DRAWN & DRAFTED BY	LIU DE LIN	TOLERANCES	ANGLE: $\pm 1^\circ$	TITLE: T-H BOBBIN EI-22			
CHECKED & APPROVED BY		$0 < L \leq 4 \pm 0.1$ $4 < L \leq 16 \pm 0.2$ $16 < L \leq 63 \pm 0.3$	pin pitch ± 0.2	BOBBIN MATERIAL:	UL REC. UL 94V-0		
				PHENOLIC (T375HF)			
				PIN MATERIAL:	PIN TENSION LOAD: 1.5KG MIN		
				CP WIRE			
				DATE: 03.04 '2014	DRAWING NO. P-2209	REV. 5

PIN SHINE INDUSTRIAL CO.,LTD.

P-2209

REV. 5

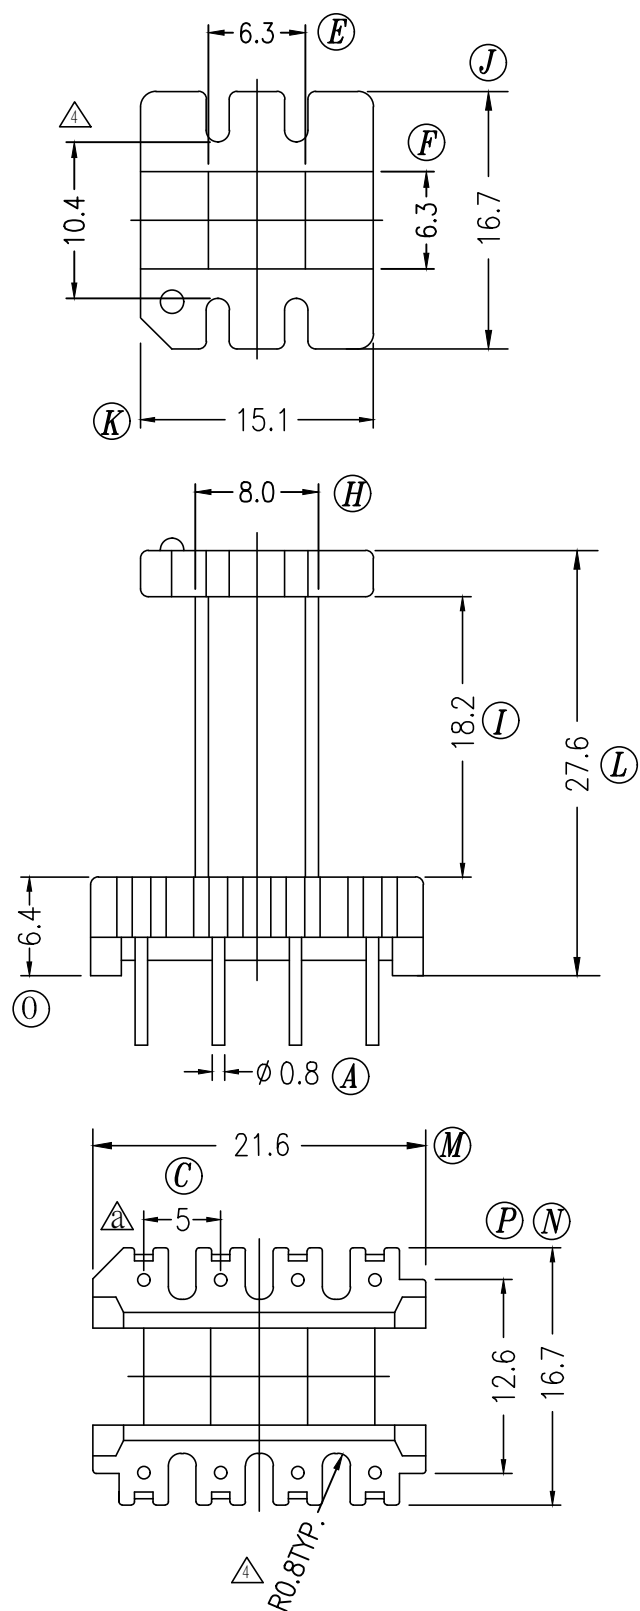
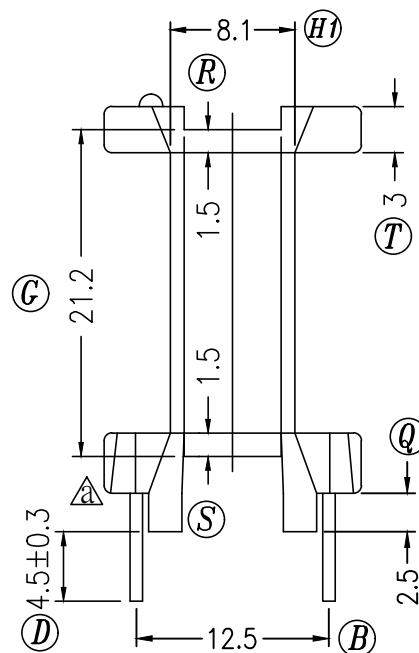
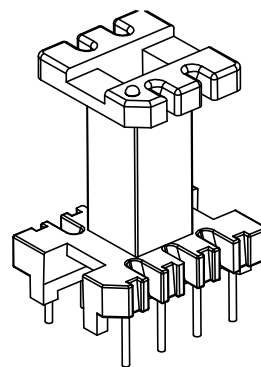
REV.	REVISIONS	REC.	DATE	REV.	REVISIONS	REC.	DATE
1	MODIFY :			4	8.8改為10.4,過線槽R角改為0.8MM,標記		
2	原品名P-2208改為P-2209			5	材質設變, T375J改為T375HF		
3	頂部加一個定位凸點
